Re: 581 American Legion Highway, DEP file number 006-1882

The attached materials and this letter represent a response to issues raised at our last hearing for the project at 581 American Legion Highway. The following is a summary of issues raised in bold italic and our response in plain text.

**1** ARCHITECTURAL SITE PLAN  
1/16" = 1'-0"

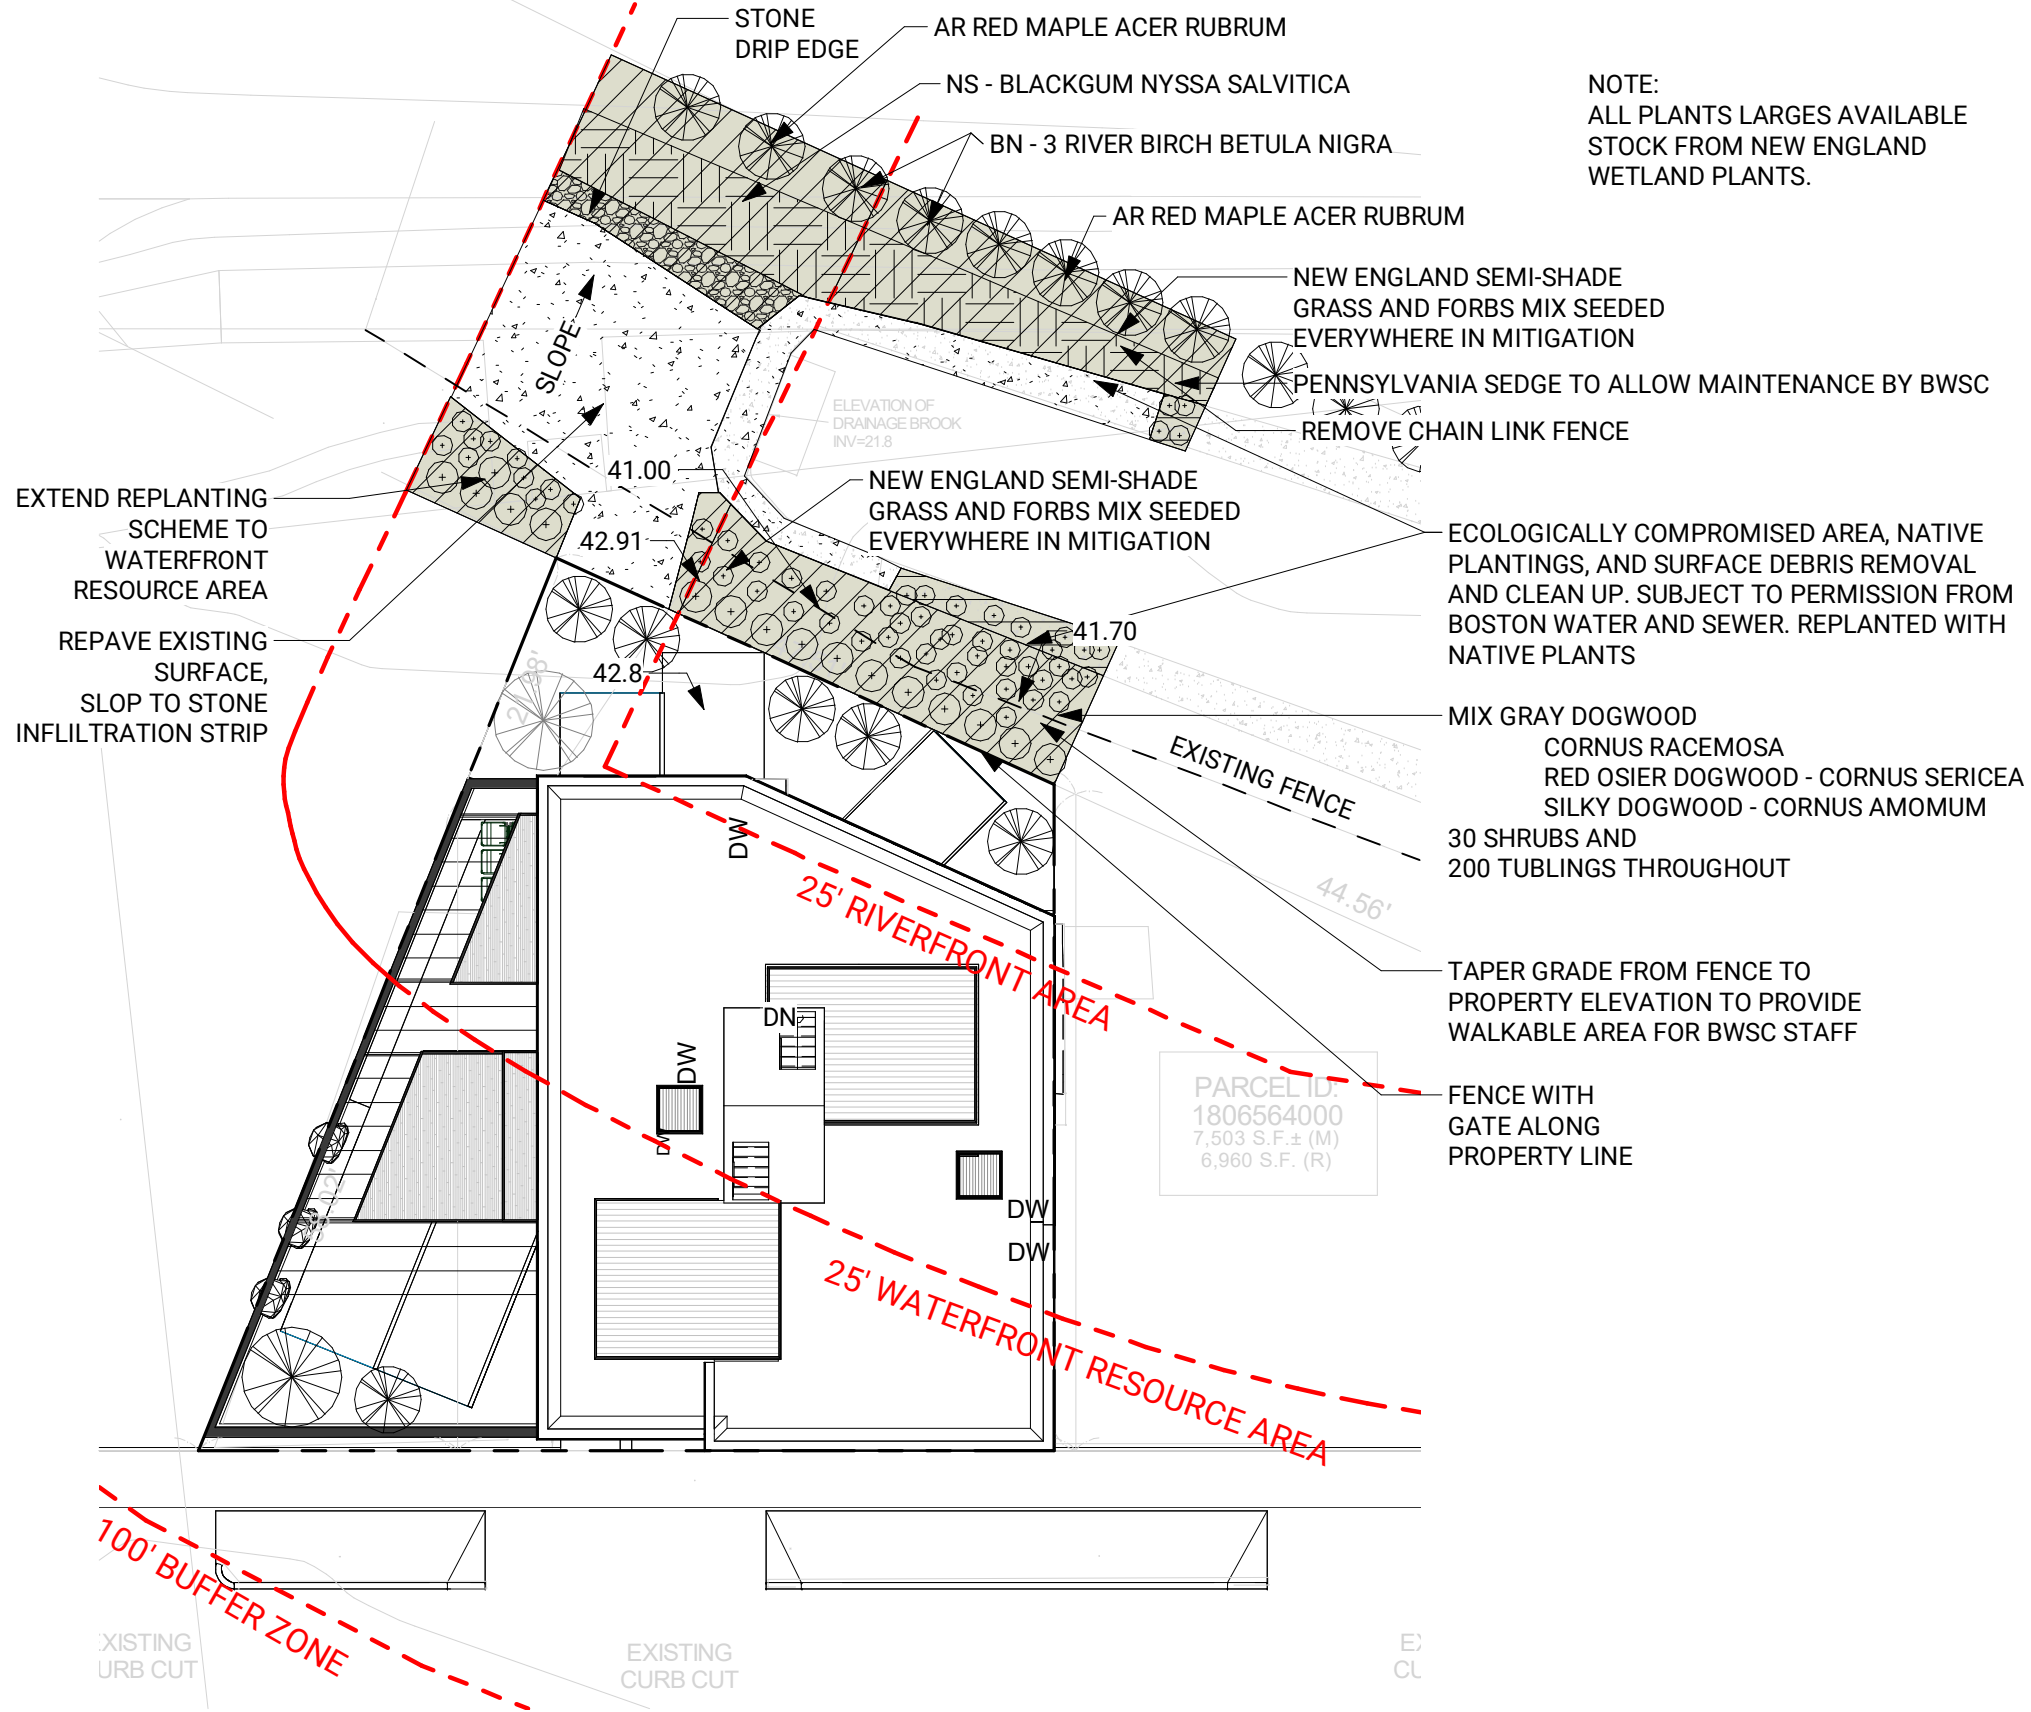
- ***Plans detailing the existing and proposed grades and what other impacts there might be to the bank and riverfront area***

We have updated the language in our plan and show the existing spot grades around the chain link fence that is to be removed. The intent is to taper the elevation from the existing fence location, which is 5+ feet in the easement to the proposed grades at the property line where the new fence will be installed. We will not require cutting into the bank. The bulk of that fence sits around elevation 42. In one location it is at 41. The closest point of the elevation 41 area is at just under 6 feet. Our proposed grades on the site plan at the property line are at 42.8, so our slope at its steepest would be around 35% and at much of it will be closer to 10%. This area is all inside the fence-line and used by

the repair shop at present. The grading is too subtle to be represented in proposed contour lines. This work will be coordinated with BWSC and subject to their approval.

I also note that we corrected the headwall location in the plan and the correction increases our mitigation planting in the riverfront area. The original mitigation plan was based on an older existing conditions plan.
